Re: Groundhog No. 5 Stockpile Workplan
Hanover and Whitewater Creeks Investigation Unit- Chino AOC

**Response to New Mexico Environment Department Comments on the Draft
Groundhog No. 5 Stockpile Work Plan for Additional Characterization and Controls,
Hanover/Whitewater Creek Investigation Unit**

Interim Remedial Action Work Plan for Additional
Characterization and Controls

TITLE
**GROUNDHOG NO. 5 STOCKPILE – 2014 IMPROVED DRAINAGE
 MODIFICATION**

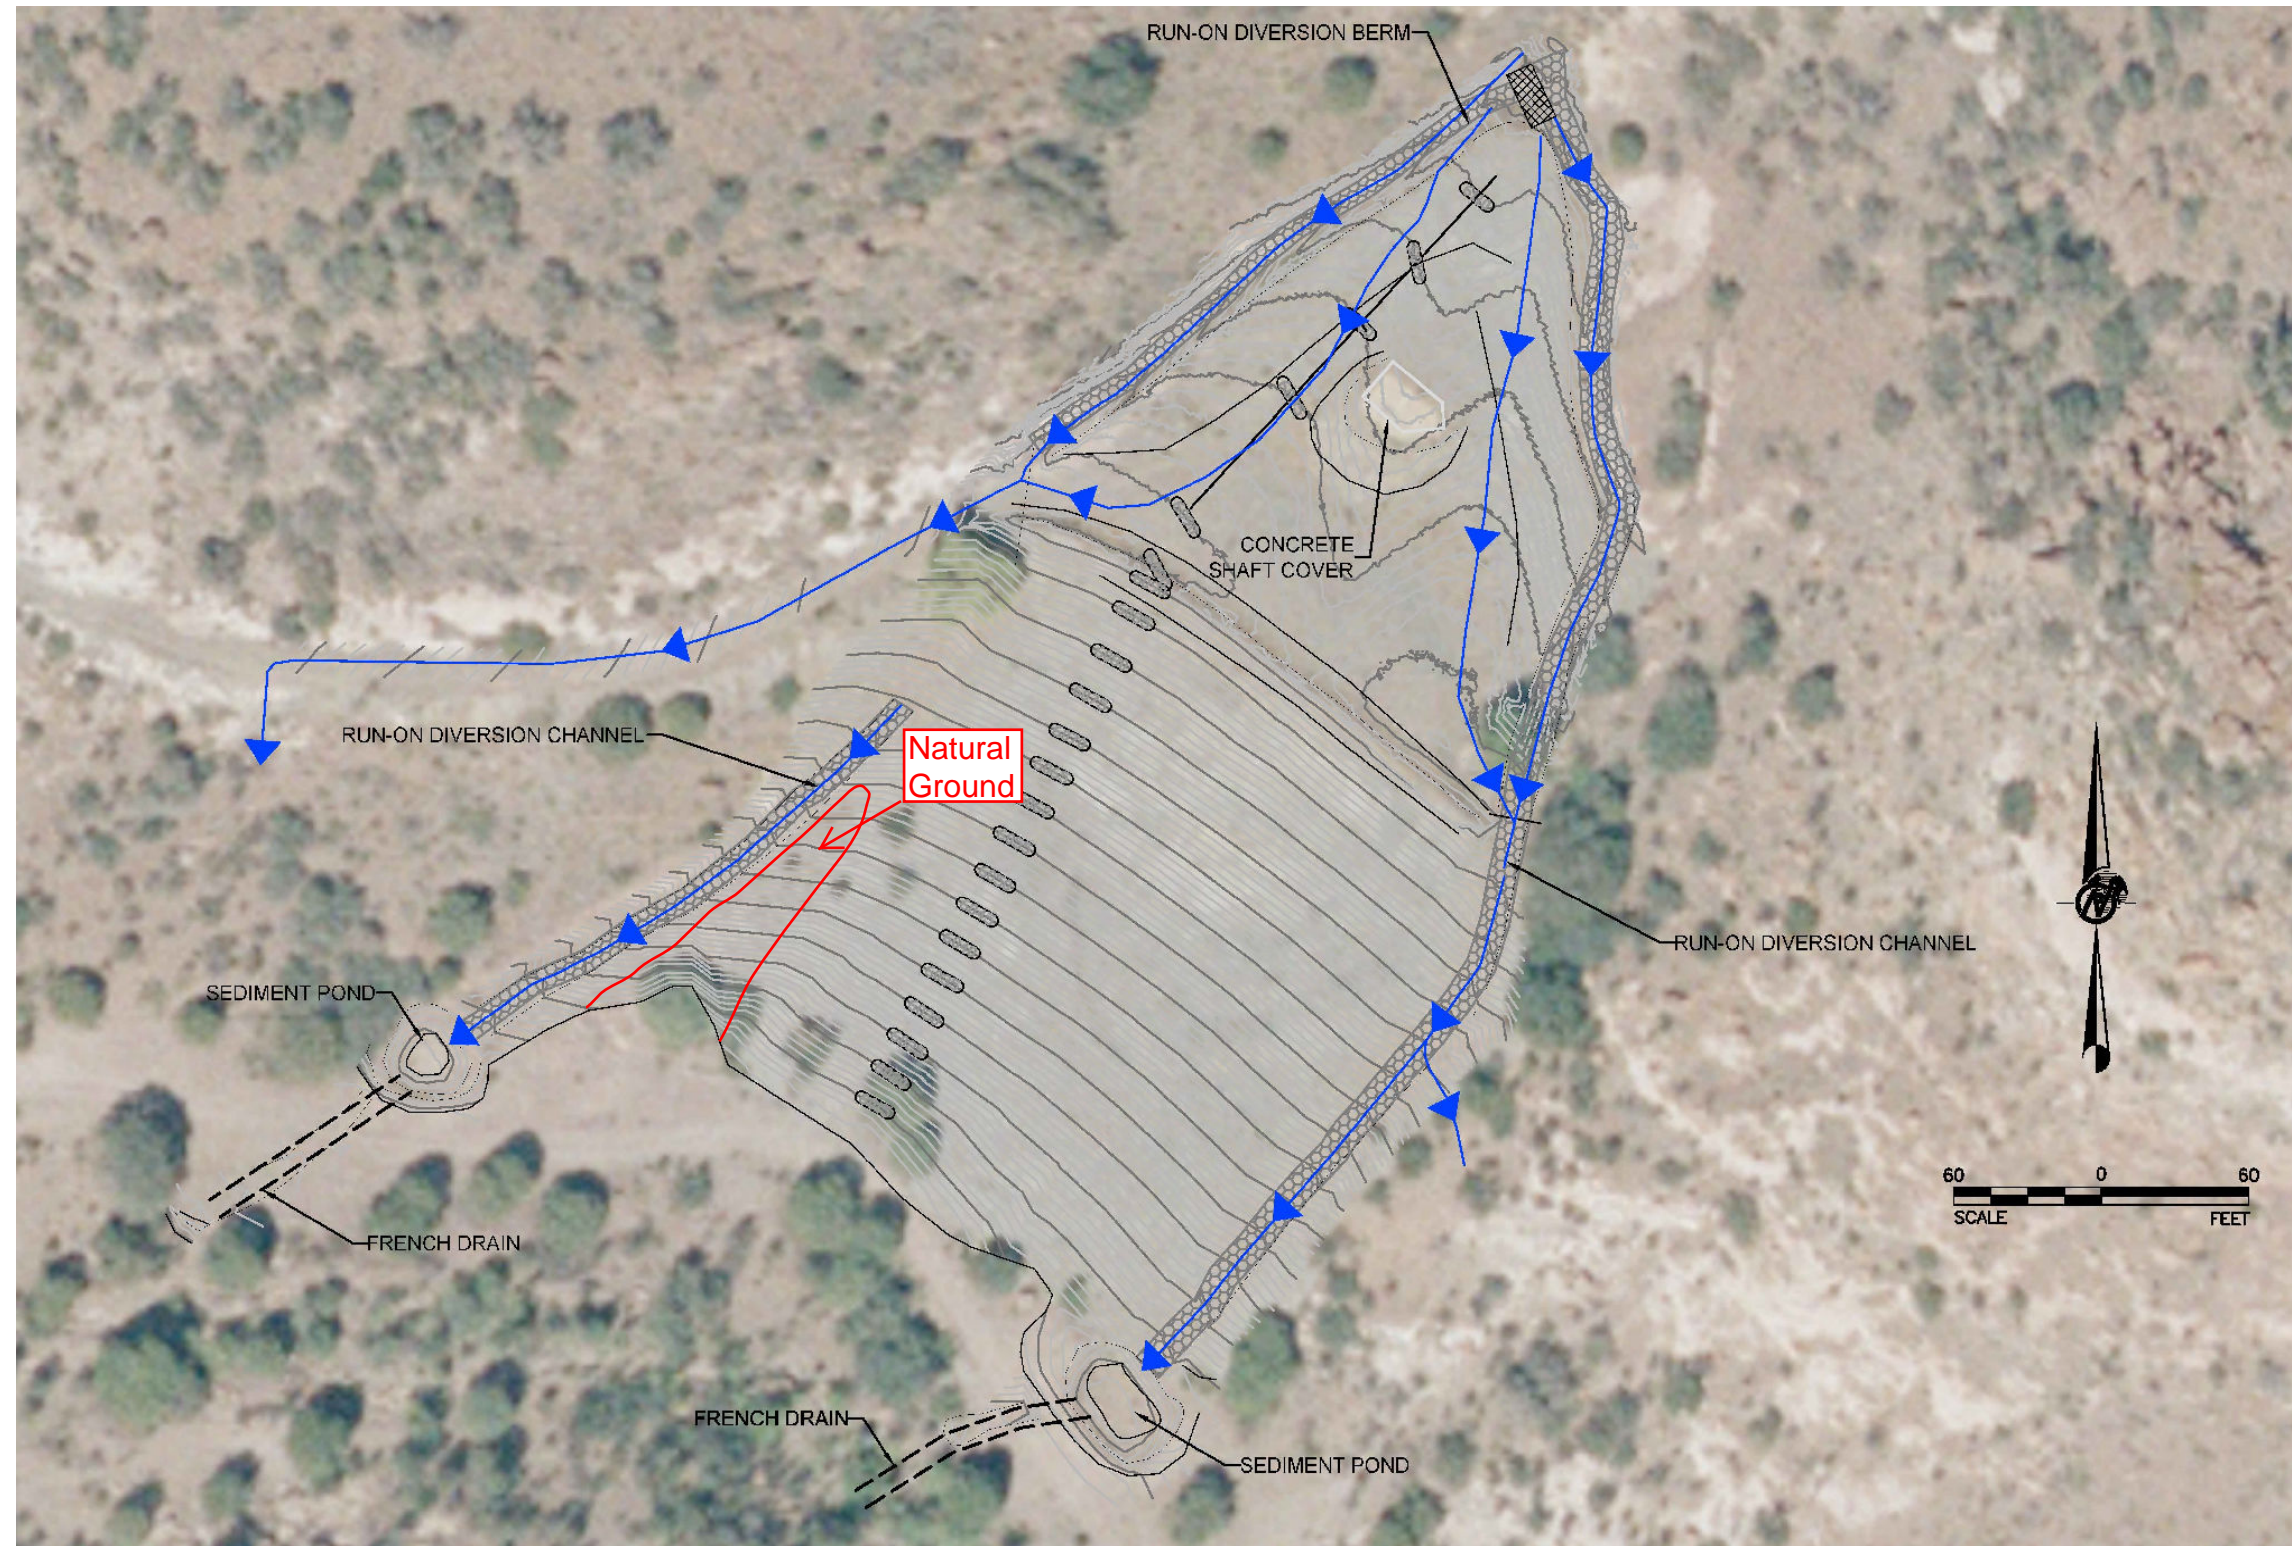
5. Section 4.0 of the Work Plan indicates that additional surface water drainage channels are in the process of being constructed at the top of the stockpile where the surface gradient is shallow to shed incident precipitation more quickly during rainfall events, and the channels will be *field fit*. The Work Plan does not indicate that the top surface will be re-graded to direct surface flows to the channels. It is not clear to NMED how the channels will collect water from the top surface if the top surface is not regarded to direct runoff to the channels. Please discuss. Additionally, if the channels are going to be *field fit*, please indicate at what gradient the channels will be constructed and discuss what measures will be taken to insure that the gradient of the channels will be adequate to minimize infiltration of water into the stockpile. It has been NMED's experience that top surface channels can be a significant source of infiltration.

7. Figure 2 (topographic map) does not include a scale. Any maps or aerial photos submitted to NMED should have appropriate scales included with them.

Chino Response: *The channels have been constructed to drain runoff from the top of the stockpile to the existing diversion channels. The channel configurations are shown on the revised Figure 2. The channels are sloped at approximately 11%.*

Chino Response: Figure 2 has been revised to include a scale.

TITLE
 HYDROGEOLOGIC CONCEPTUAL MODEL
 GROUNDHOG NO.5 STOCKPILE

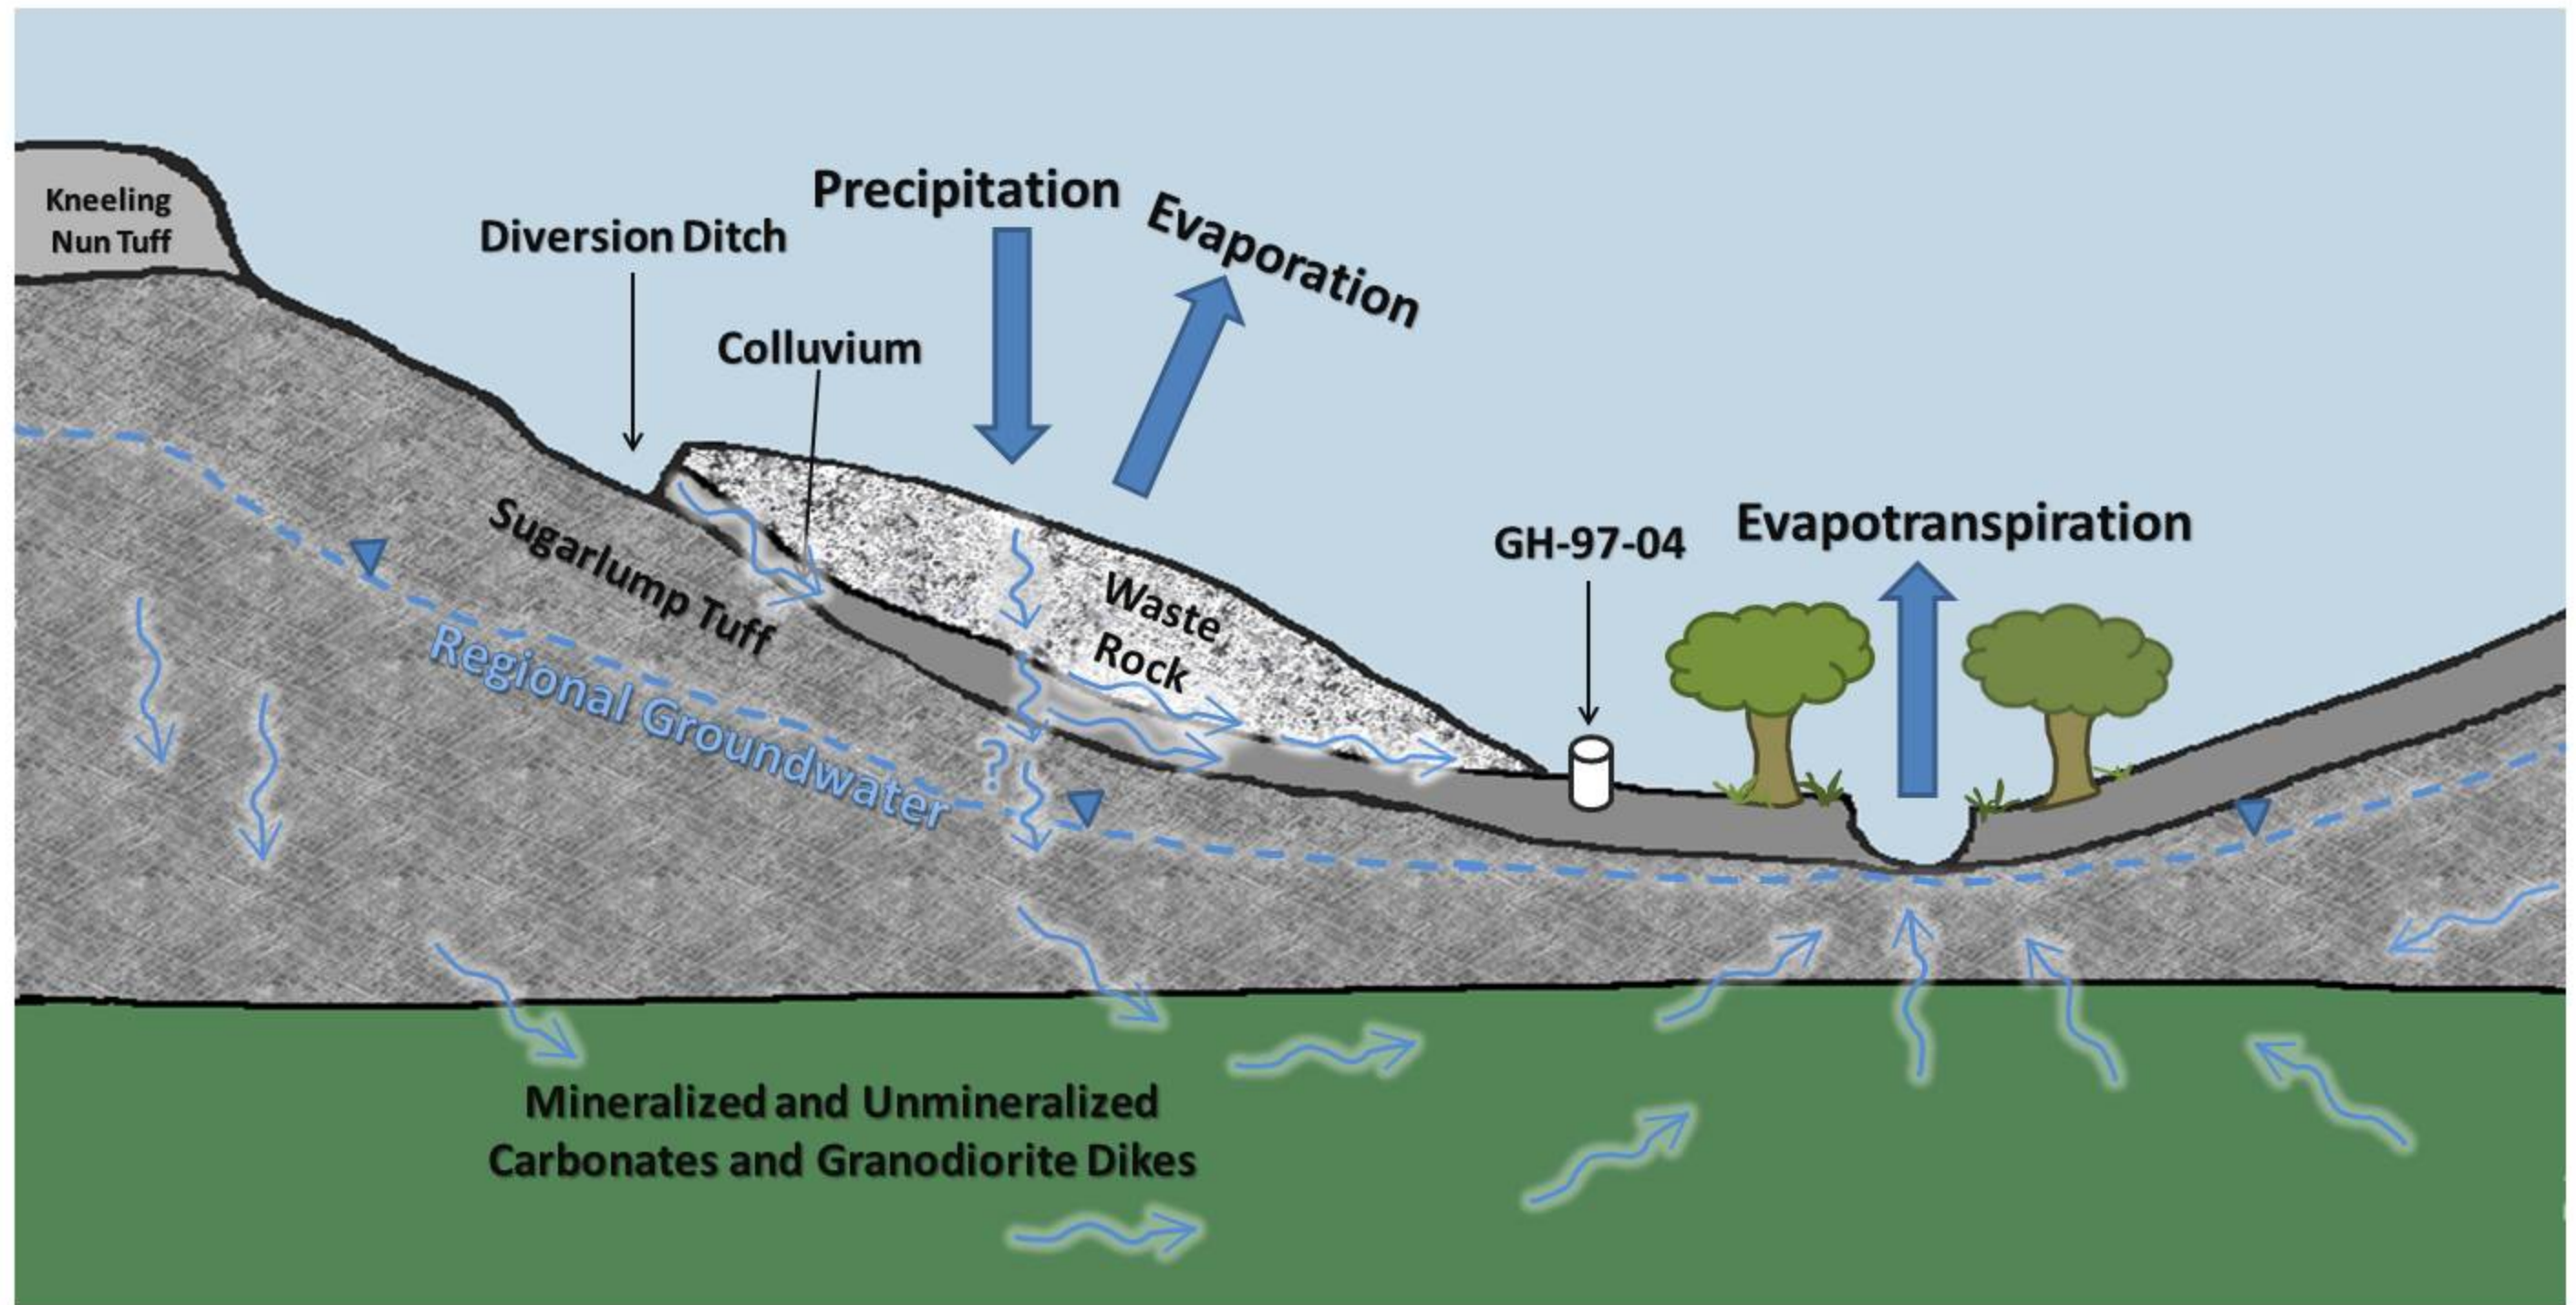
3. Figure 3 is a diagrammatic cross section through the stockpile showing a conceptual model for water inflows and outflows for the area of Groundhog No.5. The cross section uses blue arrows to show that precipitation falling on the stockpile infiltrates to the base of the stockpile and flows along the top of the underlying colluvium where it exits at the toe of the stockpile. However, the third paragraph of Section 3.0 indicates that infiltration into the stockpile that reaches a depth below the influence of evaporation will migrate downward to the colluvium and either flow along the top of the colluvium, along the colluvium-bedrock contact, or downward into the regional groundwater in the bedrock. Please clarify why the diagrammatic cross section shows water that infiltrates into the stockpile flows along the stockpile-colluvium contact, but the text indicates this is likely not the case. Additionally, please discuss the possibility that the reason monitoring well GH-97-04 often contains very little or no water is because water that infiltrates into the stockpile may be migrating downward through the colluvium into the regional water table.

precipitation. Figure 2 shows that the diversion ditches are immediately adjacent to the stockpile and Figure 3 indicates that the diversion ditches were excavated into colluvium, with stockpile material exposed on the inner wall of the diversion ditches. In addition to the Work Plan indicating water may be infiltrating through the stockpile and colluvium to regional groundwater in the bedrock (see Comment 3 above), descriptions of material encountered in the test pit logs from previous reports indicate the stockpile and colluvium are likely highly permeable. As such, it is NMED's opinion that water from the diversion ditches is likely infiltrating into the stockpile, contrary to Section 3.0 indicating the only known inflow of water to the stockpile is incident precipitation. Please discuss.

Chino Response: Figure 3 has been revised to include the possible flow paths of infiltrating precipitation along the top of the bedrock contact and downward into the groundwater. Based on observations made during the May 2014 trench excavation, well GH-97-04 may not be excavated deep enough to intersect unweathered bedrock. The trench was excavated several feet downhill from the well, but the bedrock depth appears to indicate that the well screen is still more than 3 to 4 feet above competent bedrock. The bedrock surface was observed to be weathered and stained in only the upper two to three inches, and hard and unweathered beneath, indicating flow does occur along the bedrock contact. The hydraulic conductivity of the volcanic bedrock of the North Mine Area is known to be the lowest of any of the major bedrock units in this area (Golder, 2007). The geometric mean the hydraulic conductivity of the Sugarlump Tuff, which underlies the stockpile is 8.2E-4 feet per day (ft/d) (2.9E-7 centimeters per second) (Golder, 2007). Based on this information, it is not likely that significant seepage is occurring into the regional groundwater.

Chino Response: *Figure 3 and the text have been revised to show a possible flow path from the upgradient diversion ditch into the colluvium. The ditches are sloped to drain upgradient runoff and divert it away from the stockpile. The residence time of water in the ditch is therefore limited to short periods of time during storm events that generate runoff. Therefore this flow into the stockpile is expected to be negligible. Additionally, as illustrated in the revised Figure 2, run-on diversions channeled in bedrock on the top flatter area of the stockpile now route most of the runoff stormwater away from the stockpile. This rerouting of the upgradient 2006 stormwater controls occurred earlier this year due to erosion of the original drainage system from high precipitation events in 2013. Drainage on the upper portion of the stockpile, which the draft workplan proposed to field fit as discussed below in NMED comment #5, is also routed to those rock channels.*
